01-AFC-4

Subject: East Altamont Energy Center Application for Certification
Data Adequacy Response Set 2 (01-AFC-4)

EAST ALTAMONT ENERGY CENTER DATA ADEQUACY RESPONSE SET 2

**FIGURE 8-14.2a
LOCAL HYDROGEOLOGY
AND NEARBY WELLS**

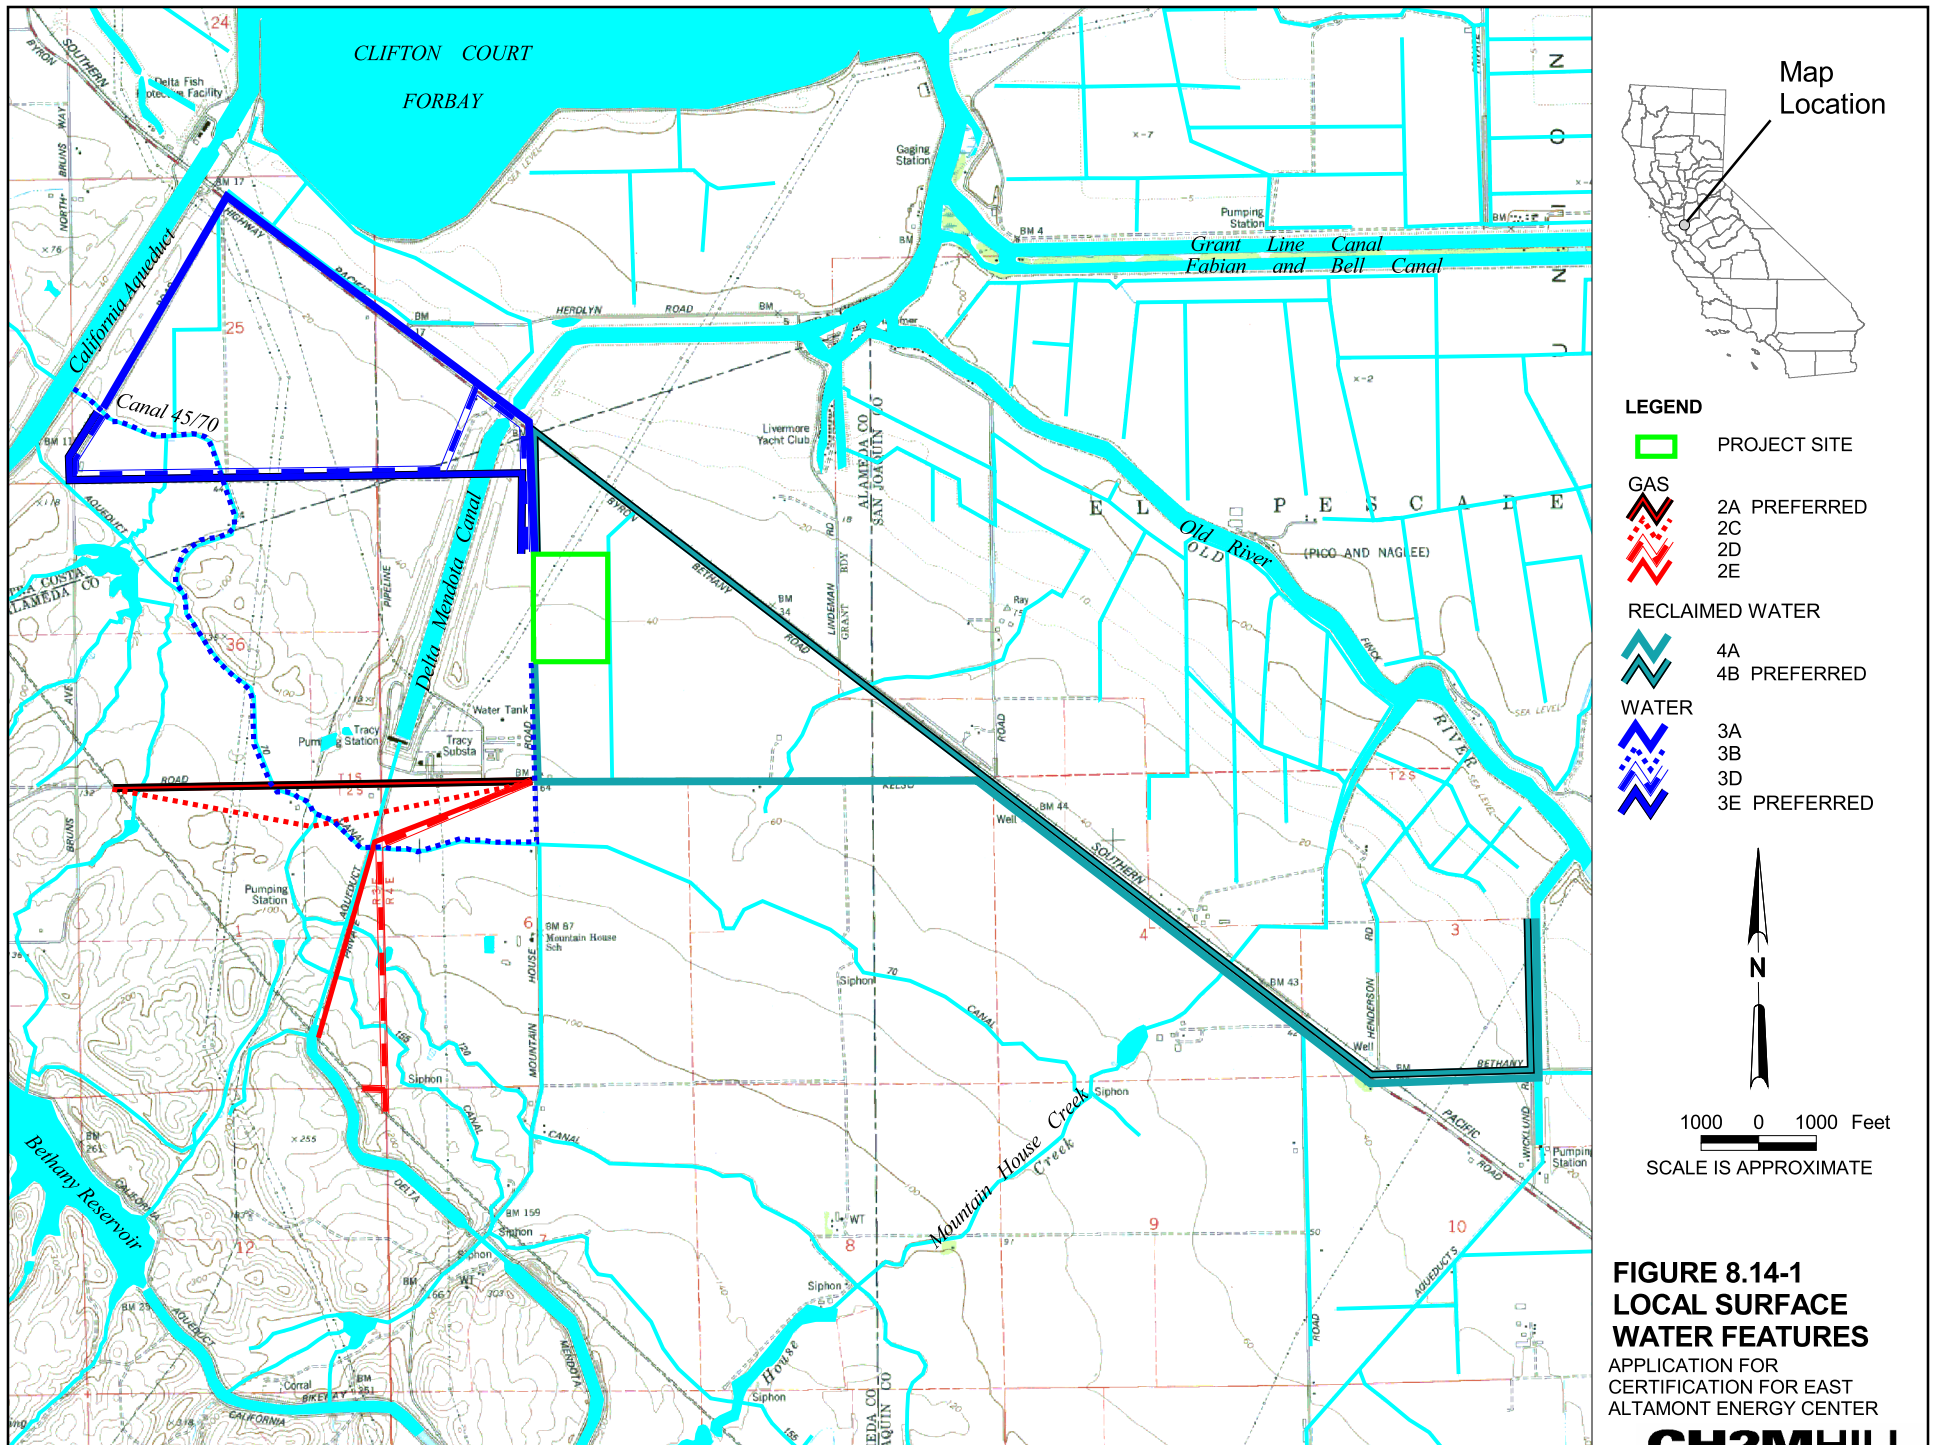
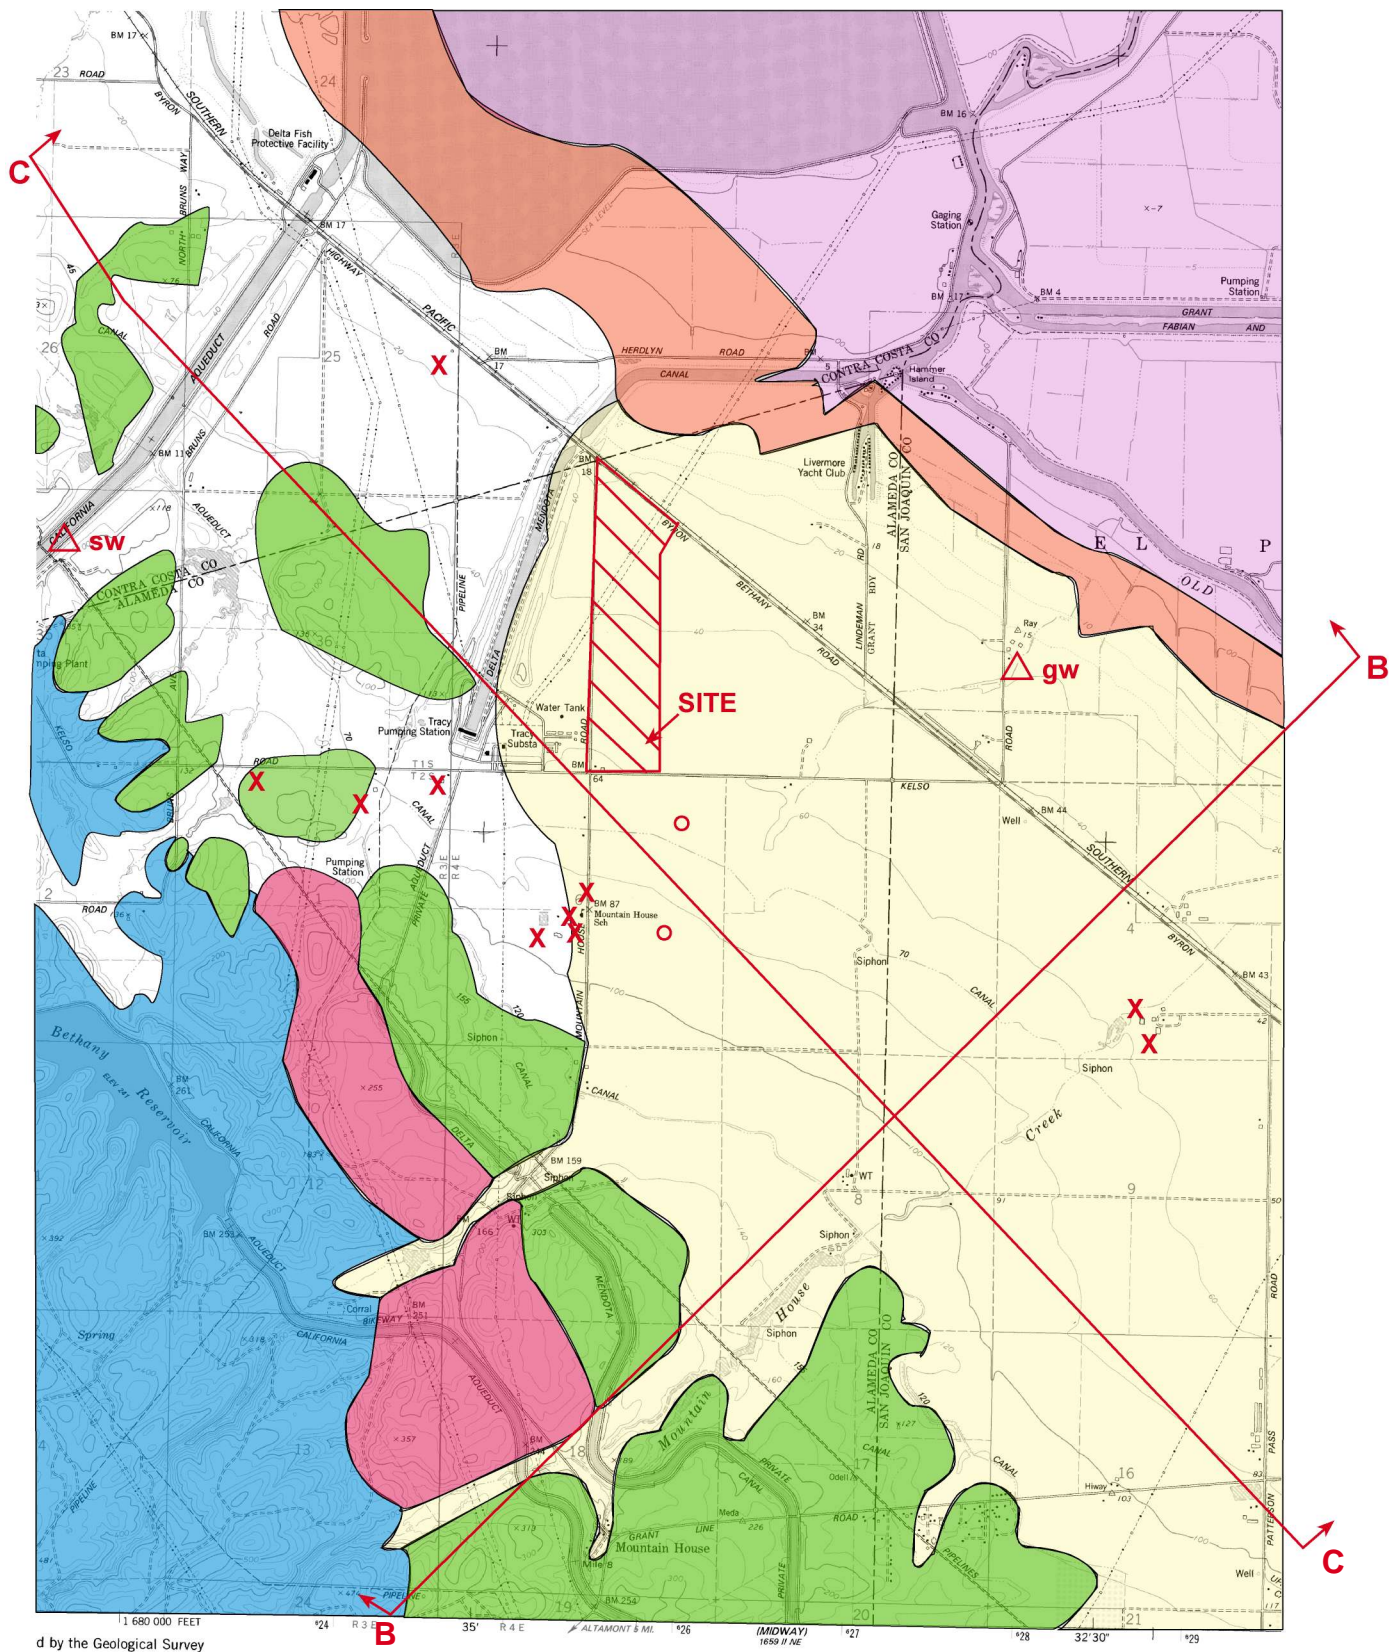
Data Adequacy Deficiency – W-3. Please provide hydrostratigraphic (map) information at an appropriate scale that clearly identifies the aquifers in the area of the project (shallow and deeper). Include in this information an identification of relative location of the needed on site well and any neighboring wells.

Well Locations, Owners and Information. There are no wells within the facility boundary. Figure 8.14-2A (attached), showing the location of all known wells in the project vicinity (according to DWR records) is attached to this response. The current well owners have not been identified. The water quality information for the well nearest to the project site is provided in Table 8.14-1.

Figures 8.14-2A and 8.14-2B (attached) provide additional hydrogeologic information for the Mountain House Fan area in the vicinity of the project. Figure 8.14-2A also shows the locations of piezometers and private wells for which well logs are available at the California Department of Water Resources (DWR). These logs indicate that the wells are screened at depths ranging from 30 to 190 feet below grade, and so are most likely screened within the Mountain House Fan deposits or the interfan deposits located between the Mountain House and Kellogg Creek Fan deposits. The well logs also indicate that the sediments encountered at the locations where the wells were drilled consist of interbedded sand and clay. Also shown on Figure 8.14-2A are the locations of the surface water sample and the well from which the groundwater sample was collected for the quality analyses shown in AFC Table 8.14-1.
